Westside Purple Line Extension Project, Section 3

Addendum to the Final Environmental Impact Report

June 2018

Figure 2-12: Westwood/UCLA Station Entrances – Proposed

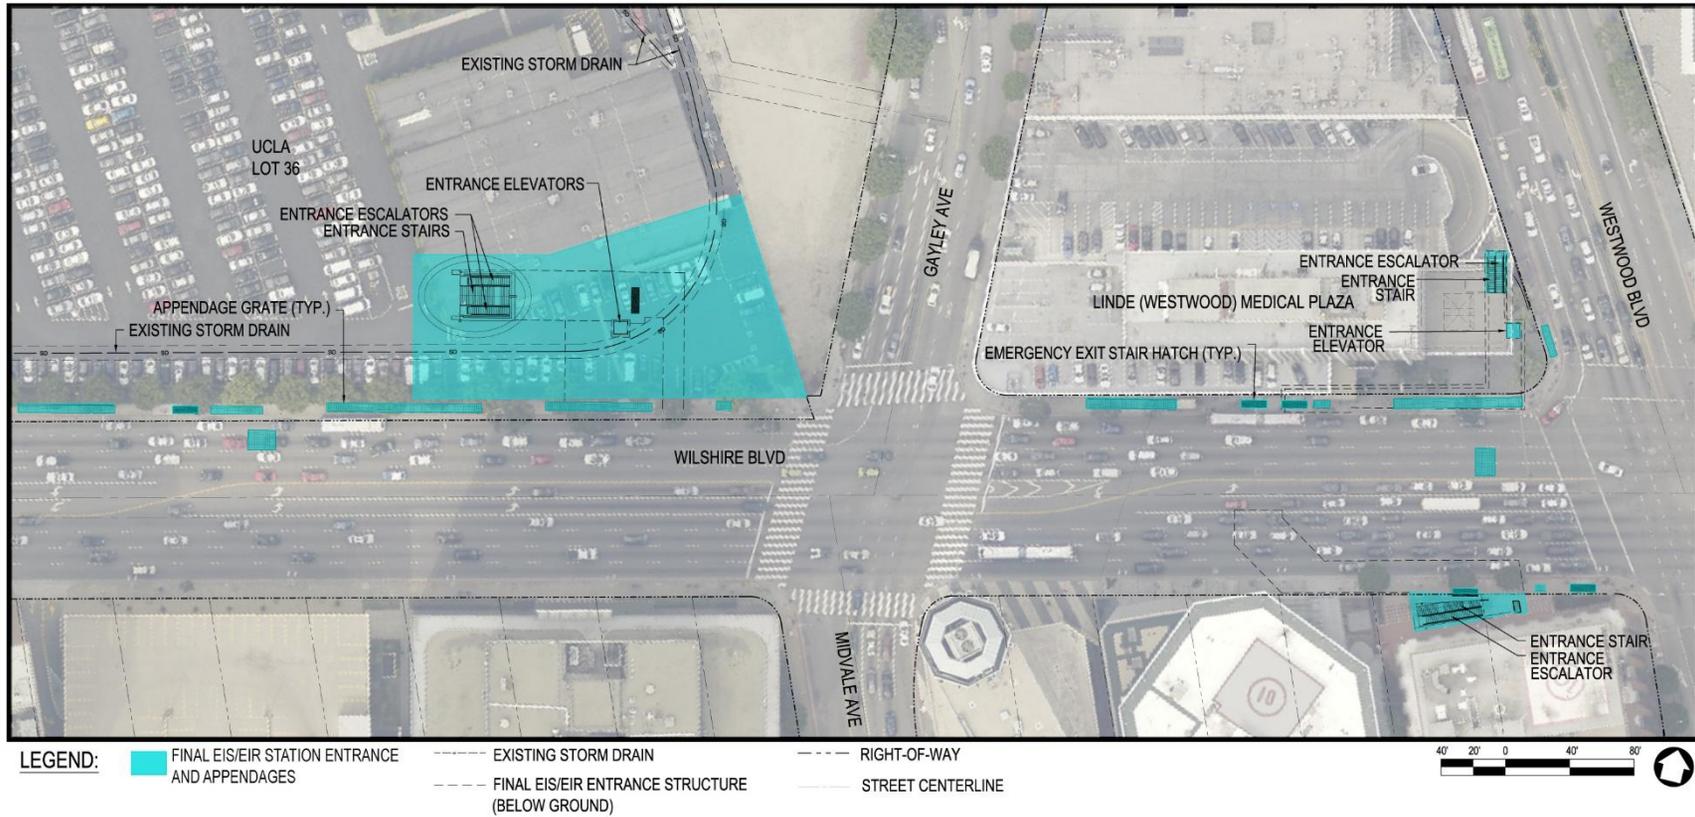
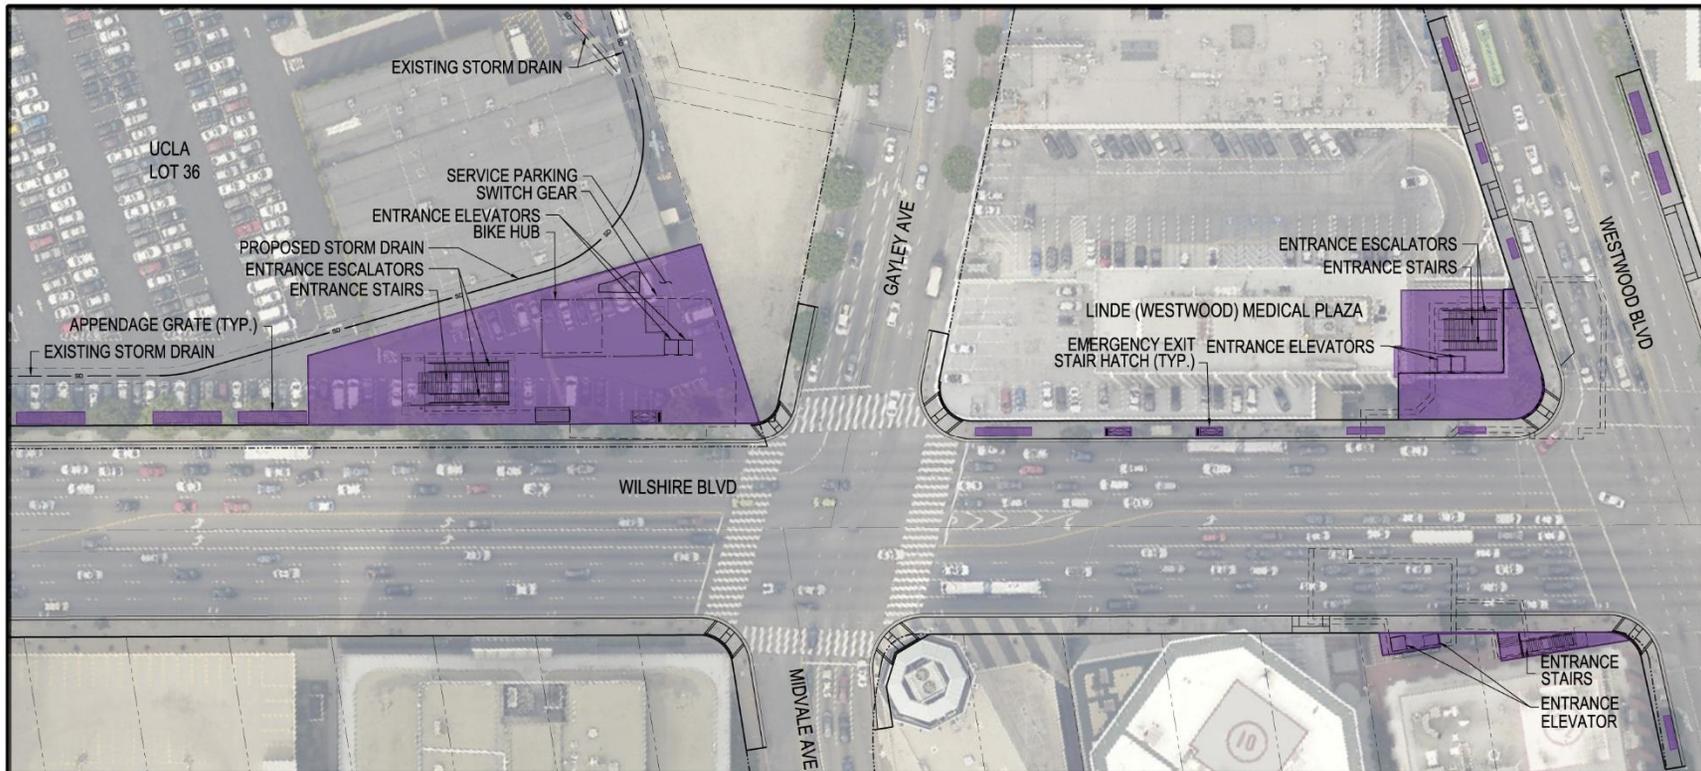
Refinements of varying degrees are proposed at all three station entrances. The locations of station entrances as evaluated in the Final EIS/EIR are shown in Figure 2-11 and the proposed locations are shown in Figure 2-12. Through coordination with UCLA, the location of the main station entrance on the UCLA Campus within the area identified as Lot 36 has been shifted slightly to the east and closer to Gayley Avenue, and the plaza has been shifted south toward Wilshire Boulevard. This design provides more real estate handed back to UCLA for future development. This refinement would require relocation of a portion of a Los Angeles County storm drain; however, no other changes would be necessary.

Currently, four planters are located within the landscaped plaza fronting the Chase Bank retail space; vegetation of various sizes and species, including a number of tall palms, are located within the planters. The planters are raised above the plaza. All four planters would be removed to support construction of the station. Metro does not propose to replace the planters when construction is complete as they present a tripping hazard and restrict pedestrian movement.

Minor refinements are proposed to the half entrance on the south side of Wilshire Boulevard. Metro proposes to replace the escalators presented in the Final EIS/EIR with elevators to improve ADA accessibility. The addition of the elevators required shifting the stairs slightly closer to the intersection of Wilshire and Westwood Boulevards in order to provide sufficient room for queuing.

Figure 2-13: Tunnel Size – Final EIS/EIR and Proposed

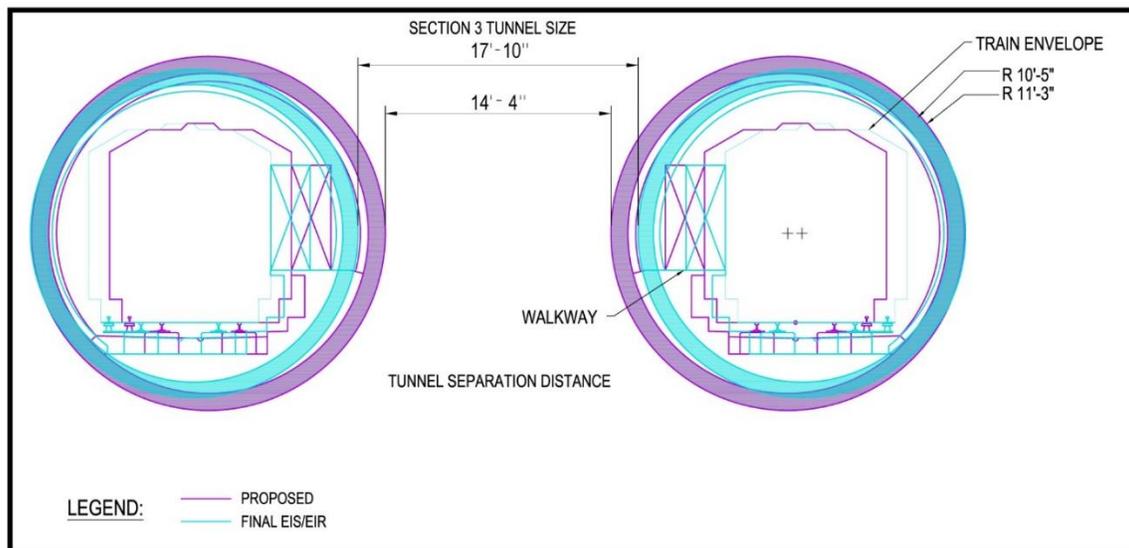
For Section 3 of the project alignment, the size of the tunnel has increased from an outside diameter of 20 feet 10 inches to 22 feet 6 inches to accommodate portions of the crossover at the Westwood/VA Hospital Station and thereby reduce the size of the cut-and-cover excavation, as described in Section 2.5. The change in diameter size is shown on Figure 2-13. The distance between the tunnels has been reduced to keep the tunnels within the subsurface easement areas identified in the Final EIS/EIR. The larger tunnels would reduce the length of the station box cut-and-cover excavation by approximately 50 feet at each crossover. As a result, the station would not extend into the I-405 off-ramp near the east end of the station, and the easement area required at the WLA VA Historic District on the west end of the station box would be reduced.

Figure 2-14: Ground Improvement Grouting at Westfield Mall

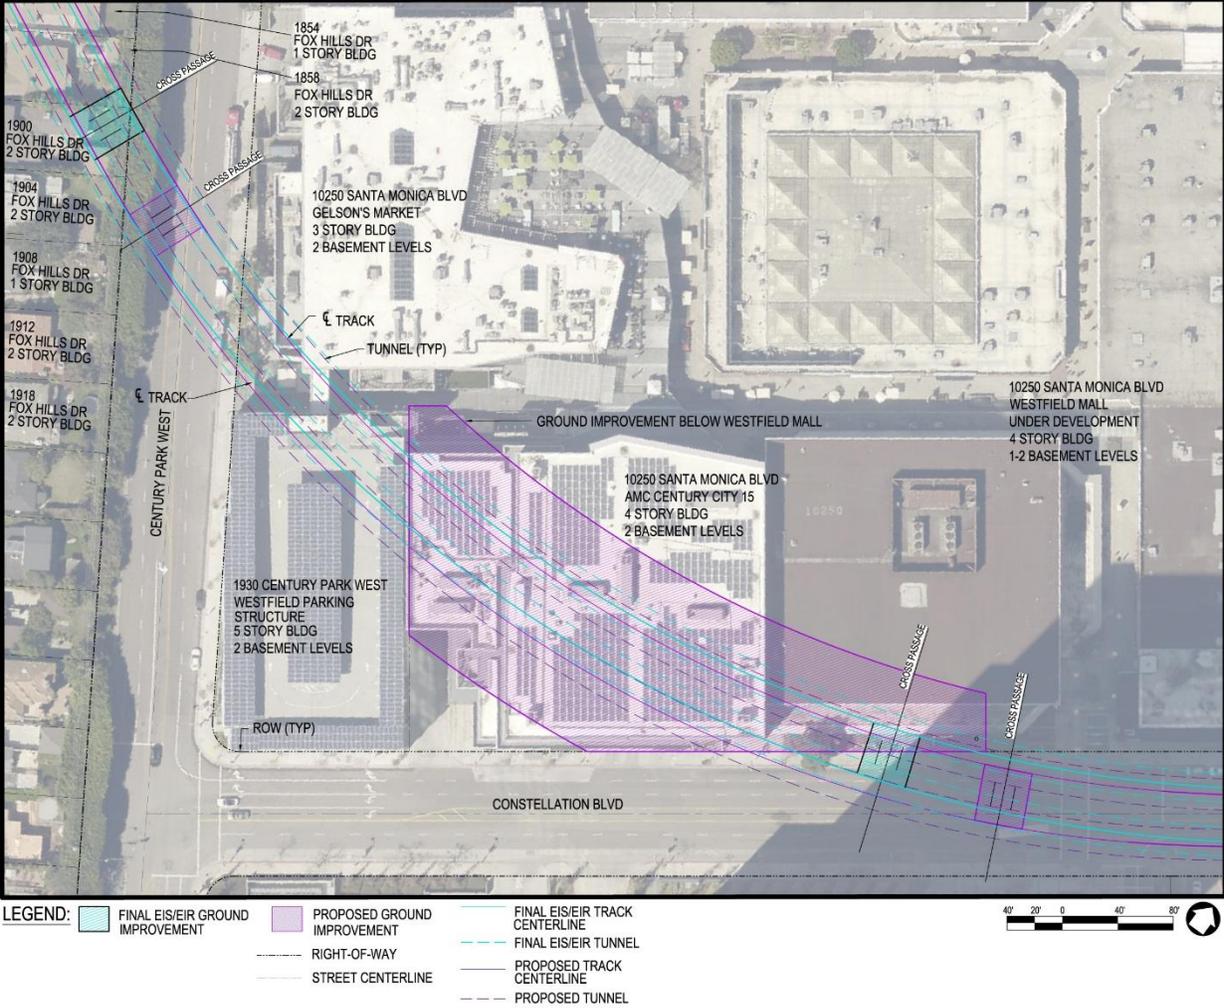
Further geotechnical studies completed in support of the advancement of design have indicated that ground improvement (grouting) may be required beneath Westfield Mall to minimize ground settlement during tunneling near the intersection of Century Park West and Constellation Boulevard (Metro 2017b). The grouting may be provided from shafts located within Century Park West and/or Constellation Boulevard (Figure 2-14). In either or both locations, the shafts would be approximately 20 feet in diameter and 80 feet deep. The shafts may be in use for several months, requiring traffic lane closures.

Figure 2-15: Ground Improvement Grouting at Sepulveda Boulevard

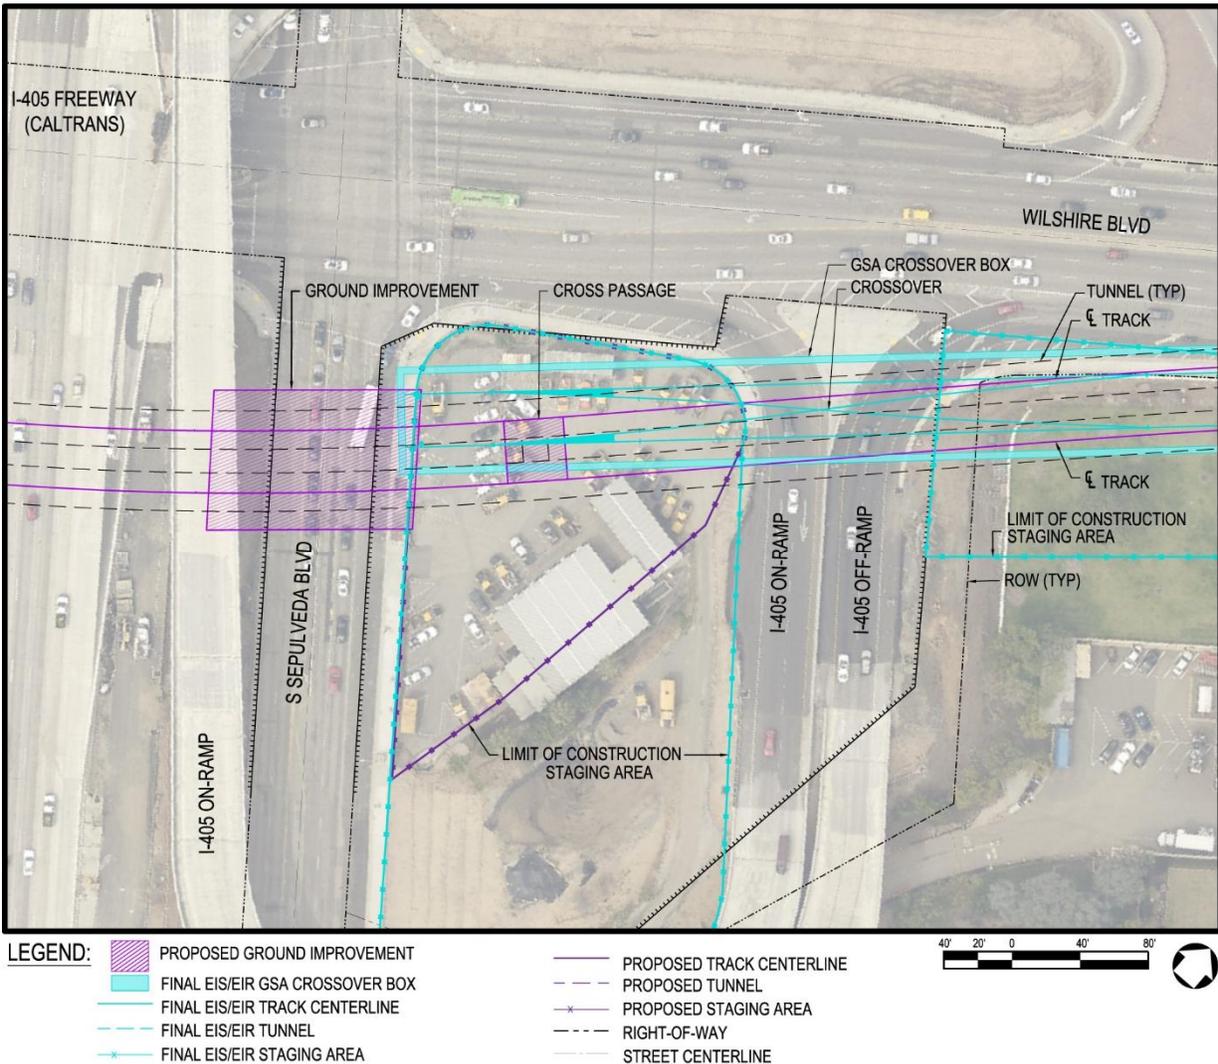
Ground improvement is also proposed at Sepulveda Boulevard from below the level of existing utilities to below the bottom of the tunnels, fully encompassing the tunnels, to protect the utilities as the tunnels pass beneath them (Figure 2-15). Several major utilities are in this location, some of which are deep. A 96-inch-diameter water main is the deepest utility, the bottom of which is 35 feet below the ground surface; the top of the tunnels is approximately 12 feet below this utility. Other utilities are as shallow as 4 feet below ground level. Grouting is therefore required to protect against excessive ground settlement effects. As stated in Section 2.2, grouting would be provided from a shaft located within Caltrans right-of-way and street closures would not be required.

Figure 2-16: Temporary and Permanent Power

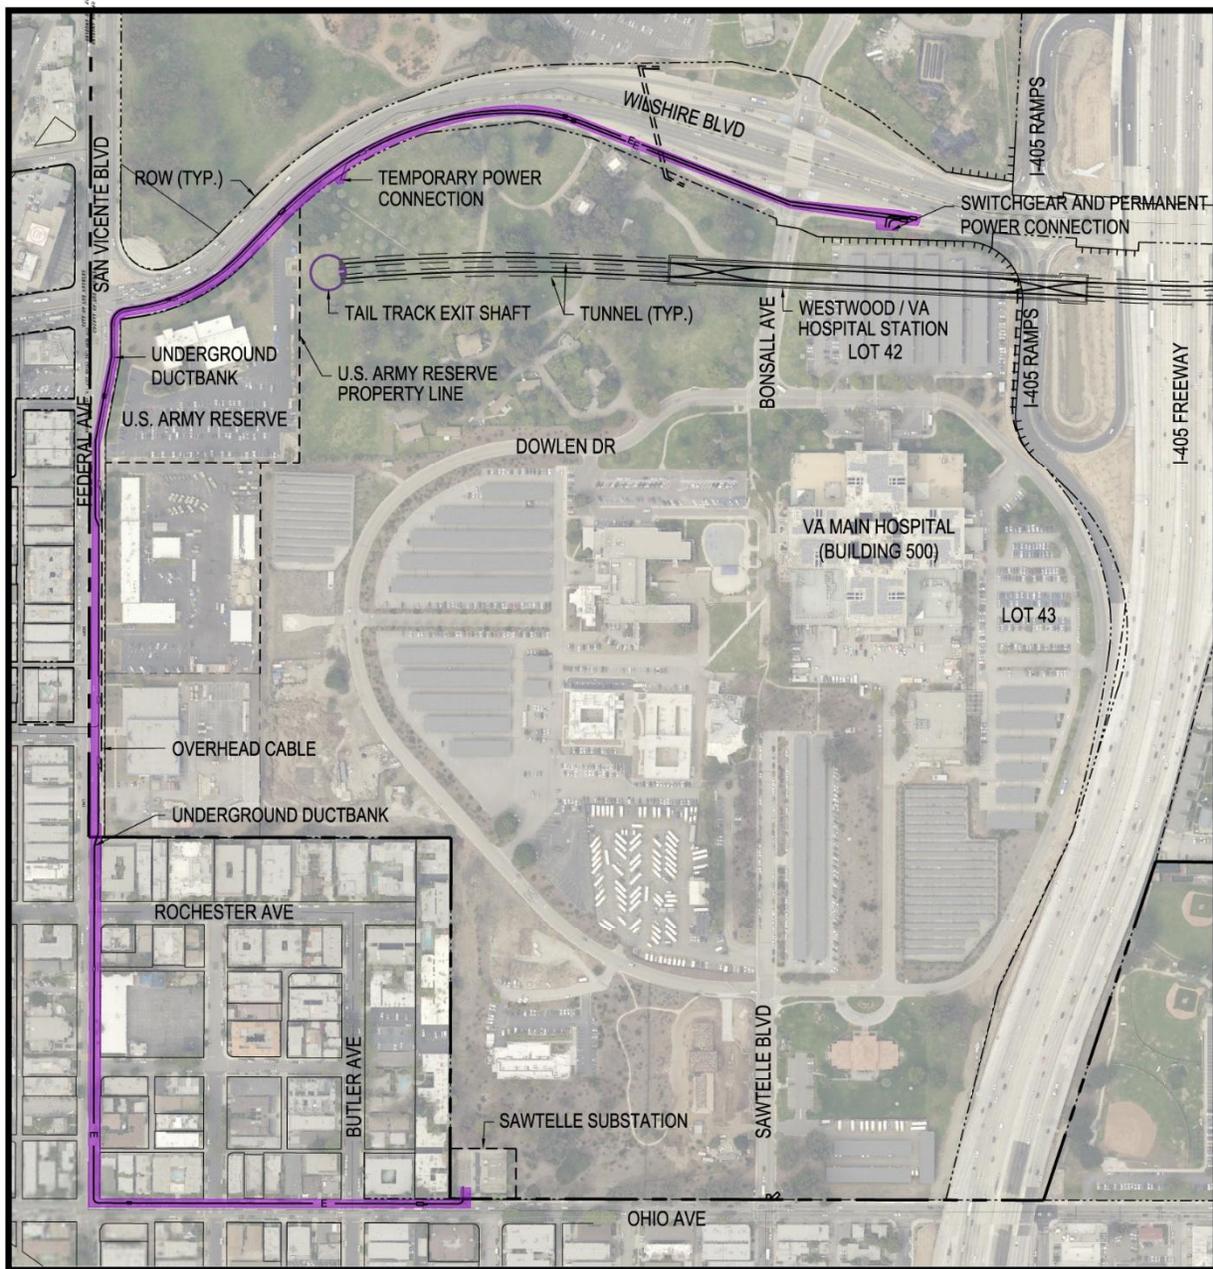
Temporary power for construction, including power required to operate the TBMs and for station construction, would require installation of new power cables from the existing Southern California Edison (SCE) Sawtelle substation to the Western VA construction staging area via Ohio Avenue, Federal Avenue, and Wilshire Boulevard (Figure 2-16); these cables were not identified in the Final EIS/EIR. The route would be a combination of new power lines on existing overhead lines and new underground conduits within public rights-of-way. SCE would install the new overhead lines, and construction of the new underground conduits would be performed by Metro. Some of these same conduits would be used for permanent primary power for the Project and would be extended from the Western VA construction staging area to the permanent Westwood/VA Hospital Station switchgear site along Wilshire Boulevard and the off-ramp to Bonsall Avenue.

Other conduits are included as backup for Metro, which is a standard request from SCE when constructing new power routes. In addition, a secondary (emergency) power source would be provided to the Westwood/VA Hospital Station from the existing SCE Colorado substation in the event that the Sawtelle substation fails, as Metro requires two independent power sources for reliability. Details of new power line are still being determined, but the power line would be within the public rights-of-way and is expected to use existing SCE overhead infrastructure for the majority of the route as well as some new underground conduits constructed by Metro. The civil work would be carried out by the Metro contractor for the area. The conduits are expected to run underground and parallel with the Sawtelle route, from Texas Avenue to the Westwood/VA Hospital Station switchgear.
